Comments on draft Task 7 of the preparatory study for windows - Lot 32

March 2015

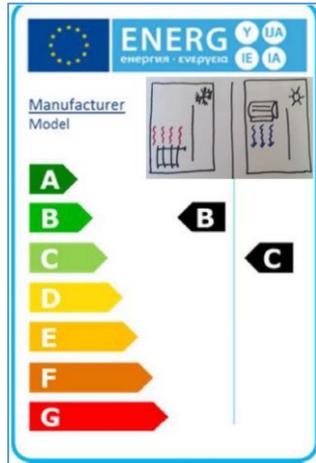
We recommend to re-work the icons used to represent the heating and cooling performances. The below proposal using the symbols of a heater and an air conditioner should be assessed:

If climate conditions are to be represented in the label, we consider that a map with climatic zones would be easier to understand, like in the case of the labels established for heaters and air conditioners. We therefore invite the study team to propose an option with a map.

➔ Review the label proposals to make them easier to understand.

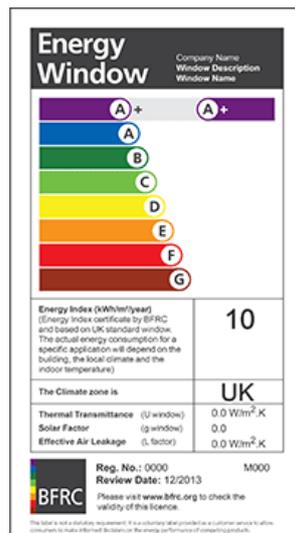
We strongly disagree with this statement and think that both the label and fiche should contain information on functionality which is common practice, as well as information on other environmental aspects that are relevant for the user. On the option of including the U_w -value, the g -value and the air leakage in the label, the study team explains that this information would be too technical for laypersons. We disagree with this approach as more knowledgeable consumers, installers and retailers (cf page 101) could benefit from this information. The UK label which is well-arranged and understandable could be used as an example on this aspect:

Furthermore, we invite the study team to also consider adding the acoustic performance, as well as the light transmittance of the glazing on the label.

→ Use the label as an opportunity to give information on the functionality of windows, thanks to information such as the U_w and g-values, air leakage, acoustic performance and light transmittance.
→ Suggest a way of expressing in an understandable way, the impact of orientation on cooling and heating performances in the product fiche.
